EVALUATION OF THE WIPP PROJECT'S COMPLIANCE
WITH THE EPA RADIATION PROTECTION STANDARDS
FOR DISPOSAL OF TRANSURANIC WASTE

March 1998

FOREWORD

Fig. 21. Permeability vs. Porosity Model With BRAGFLO for Left) Marker Bed 139 and Right) Marker Beds a and b.

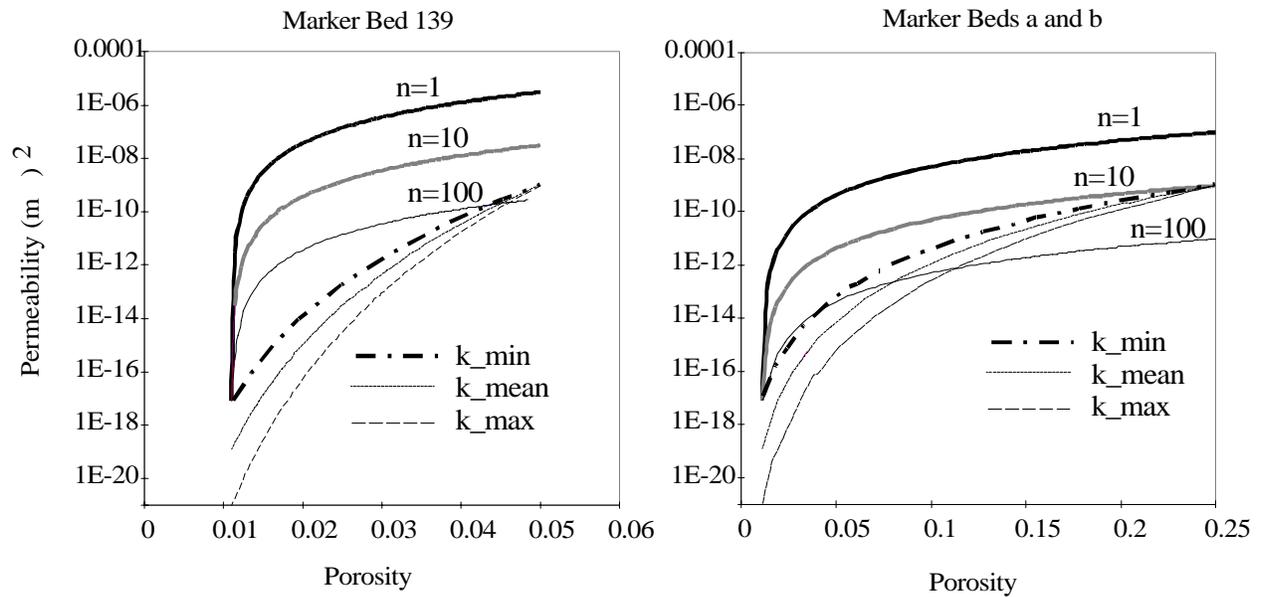
Our conclusion is that the conceptual model BRAGFLO for anhydrite fracturing may be a valid description for pore pressures less than 1 MPa below lithostatic but a cubic law formulation of the permeability-porosity relationship is valid above this threshold. As demonstrated by Freeze et al. (1995), the BRAGFLO parameters can not be set to reasonably represent this region. Figure 21 is an updated version of Figure 2 of Freeze et al. (1995). The BRAGFLO model is based on CCA parameters for marker bed 139 and anhydrite layers A and B respectively. The figure shows the permeability-porosity relationship of the BRAGFLO model to a cubic law based model for multiple fractures. Our concern is that the BRAGFLO model under-represents permeability by more than four orders of magnitude for small porosity increases. By setting the model parameters to match a cubic law fracture model at large porosity, a large error may have been introduced for small porosity changes.

Figure 3. Minnable potash.

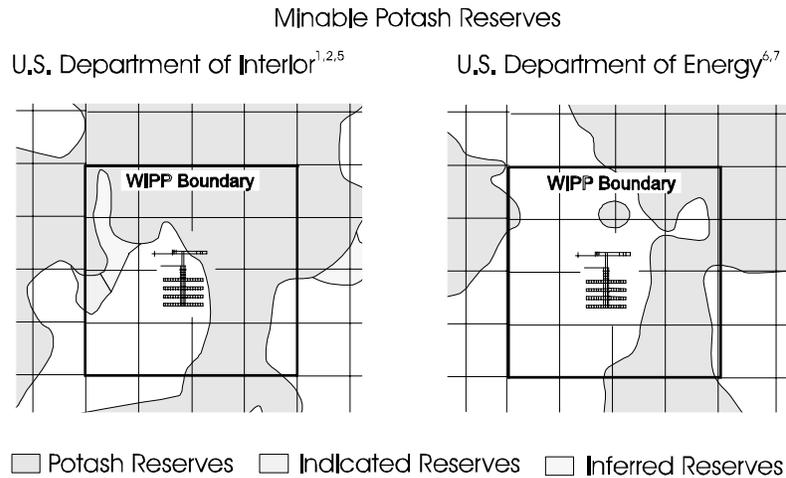
Figure 3 shows the different estimates by DOE and DOI of the extent of minnable potash within the WIPP site.

Figure 4. Potash leases within the Delaware Basin and minable potash not yet leased.

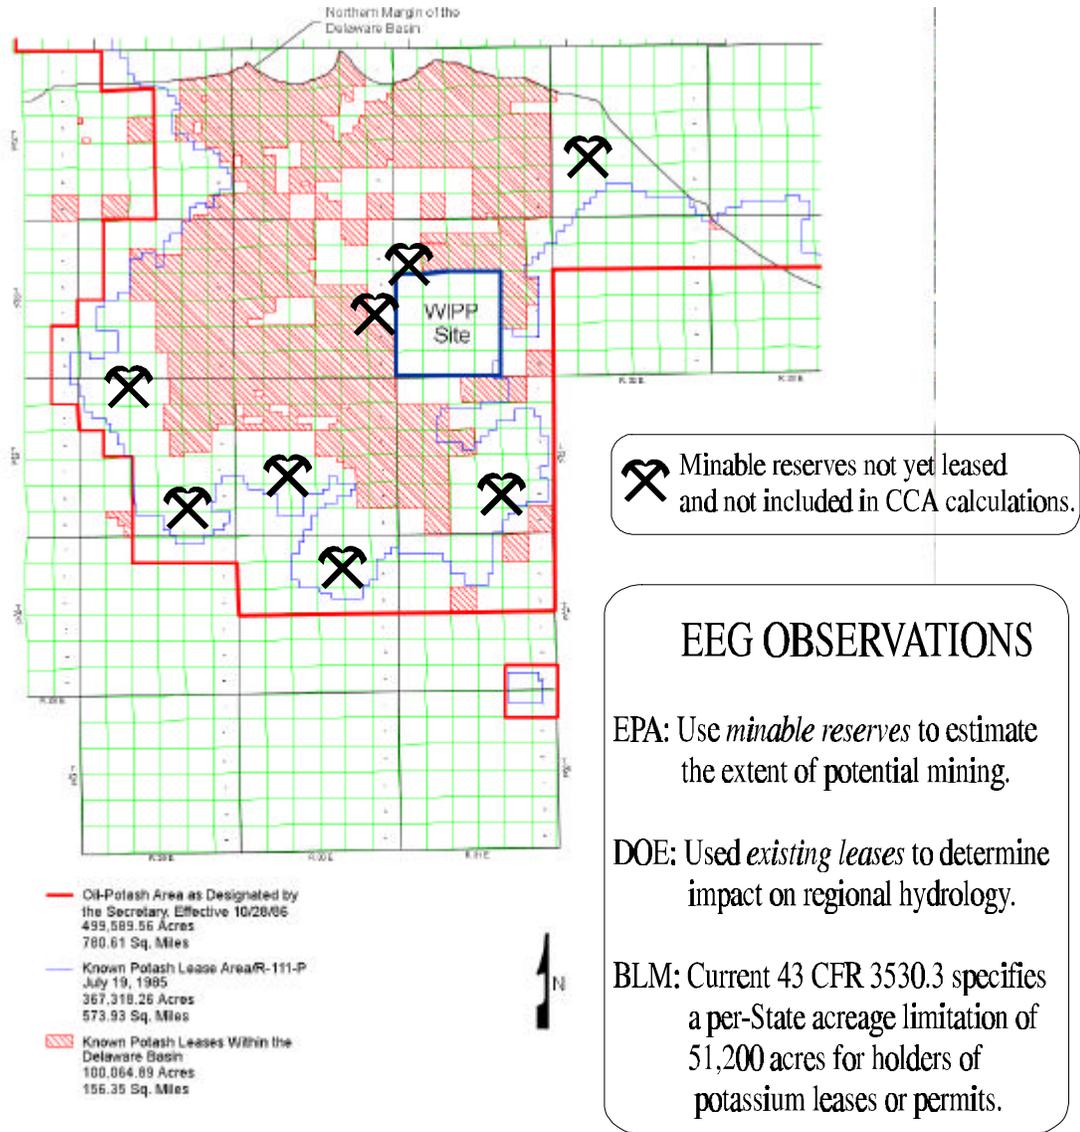
As shown in Figure 4, the CCA does not include the impact of potash mining in unleased areas which will also affect the regional hydrology. 40 CFR Part 194.32 states:

Figure 2: Cumulative Net Brine in and outflow at Repository, FEP S-1 Analysis From Vaughn et al, 1996.

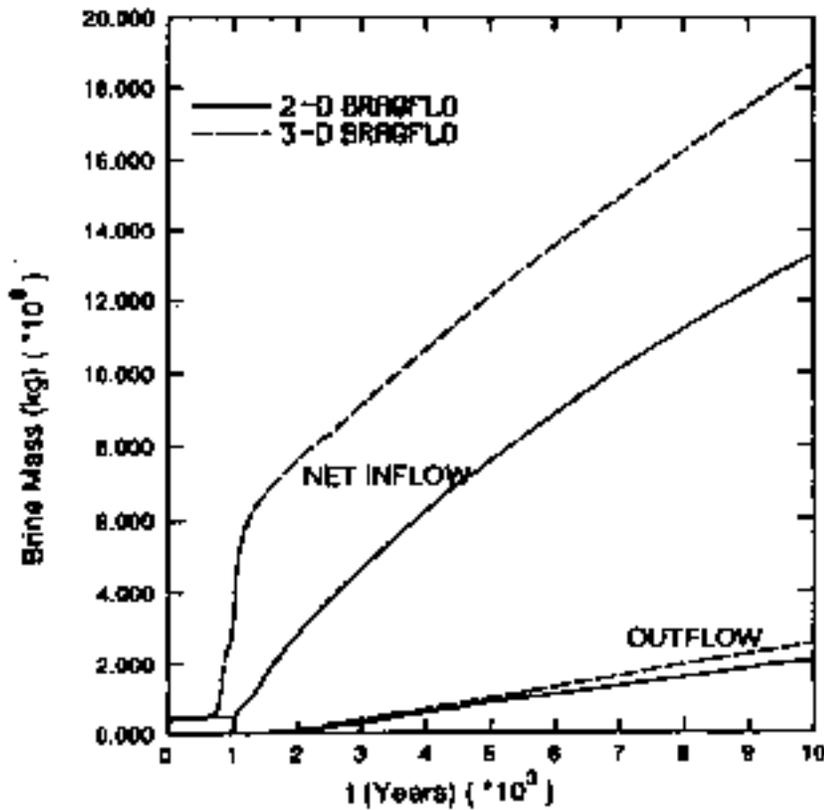
Figure 2 depicts the calculated brine inflow and outflow rates. The figure shows a large difference in calculated inflows of the two models during the period of 700 to 1,000 years. Figure 3 reinforces the perception that the brine inflow in the 3-D model is large. As shown in Figure 3, during the 700 to 1,000 years period the 3-D model shows a decrease in gas saturation of 0.05. Our concern is that if the brine inflow calculated in the 3-D model persists for thousands of years then the 2-D model calculations significantly under-predict repository saturation at high pressures.

Figure 4: Three dimensional scatter plots for volume of brine reaching the surface due to direct brine release for a drilling intrusion into the lower panel. From Helton, 1996.

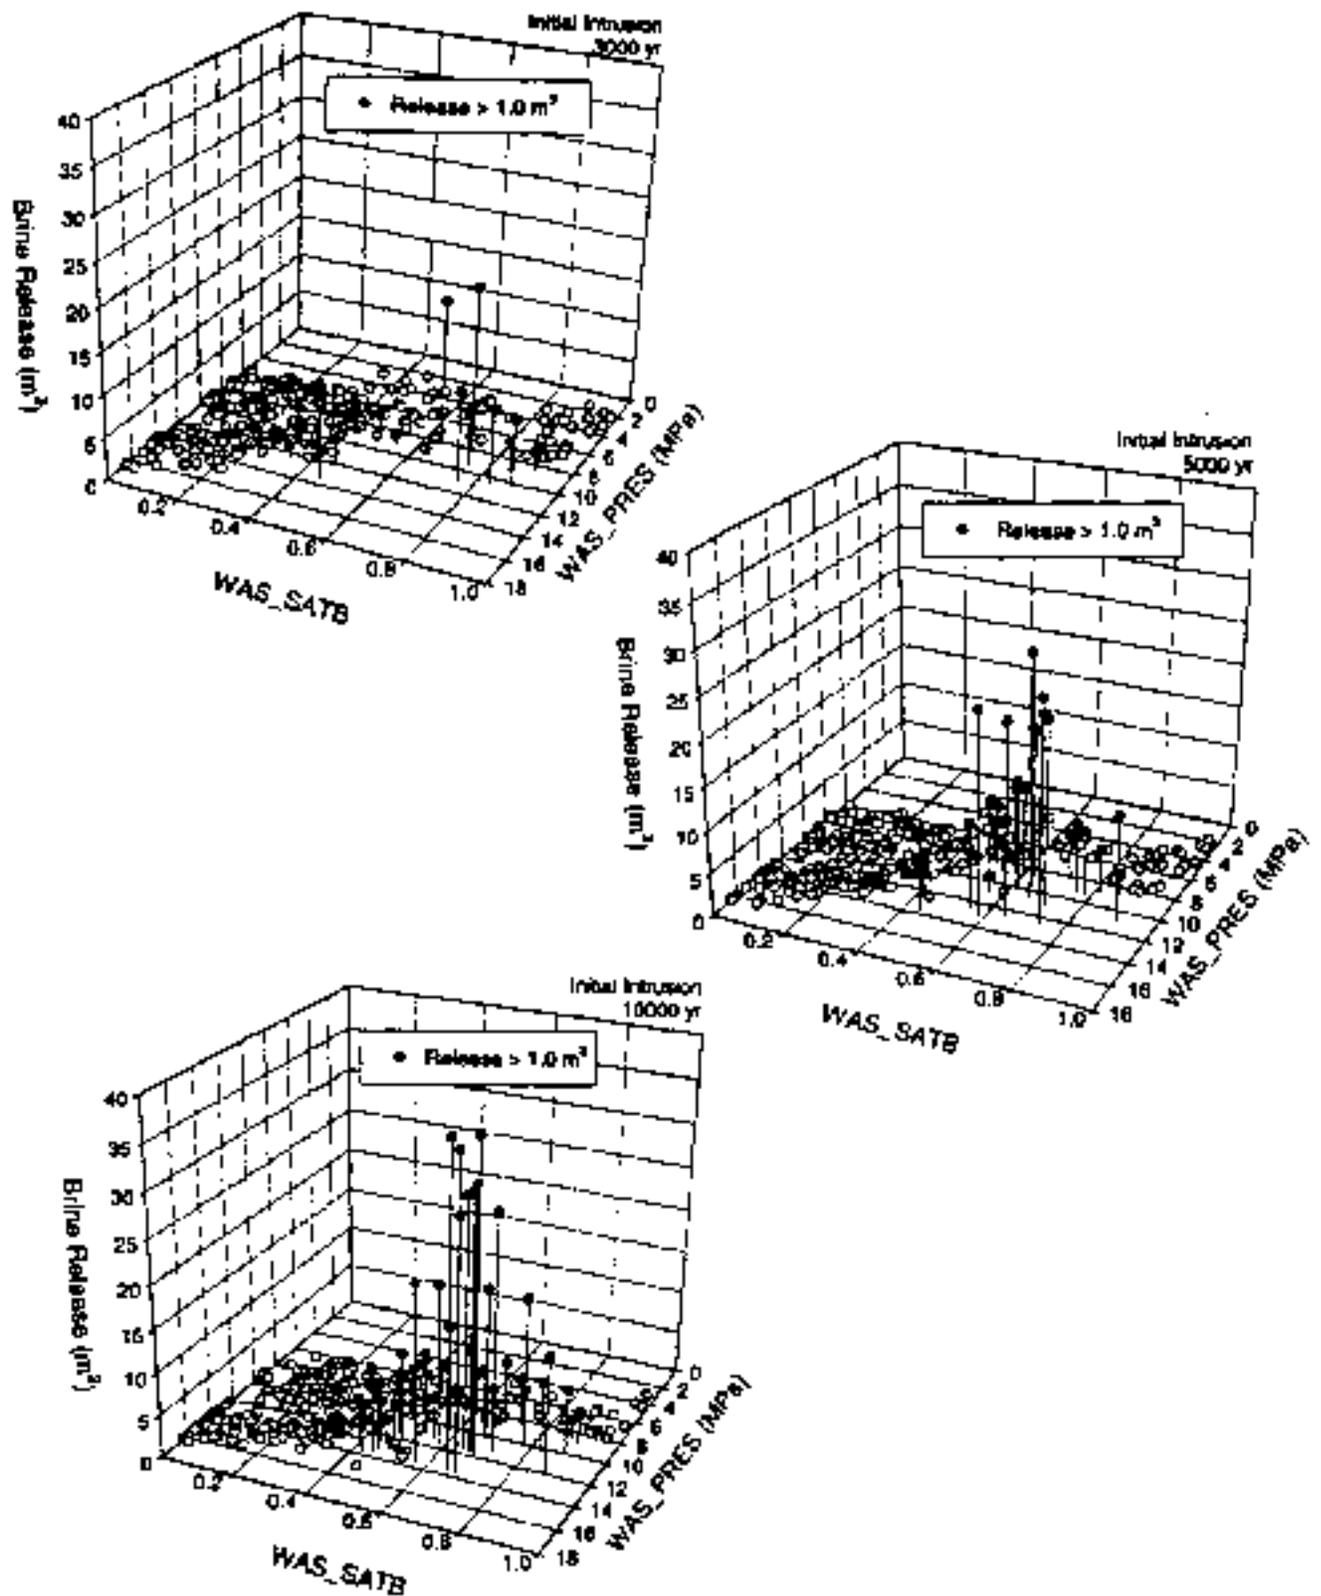
Greater saturations could lead to much larger direct brine release calculations. Figure 4 (Figure 5.1.5 of *Helton*) is the basis of this contention. Figure 4 depicts the relationship of calculated direct brine releases to repository conditions at three separate times. The average repository brine saturation and repository pressure are plotted for each vector on the horizontal plane. A vertical line connects the plane to a small circle at the level of the vertical axis corresponding to the volume of brine calculated to reach the surface. Calculated releases greater than one cubic meter are highlighted using a filled circle.

Figure 4 indicates that there were few calculated direct brine releases when the calculated repository pressures exceeded 12.7 MPa and almost none when the pressure exceeded 14 MPa. Almost all of the larger calculated direct brine releases occurred when brine saturations were above 0.5, a condition never calculated at pressures above 14 MPa. The FEP S-1 analysis suggests that the potential for many of the vectors with great repository pressure to also have large brine saturations. Thus calculated direct brine releases might have both larger volumes and greater frequency in the performance assessment.
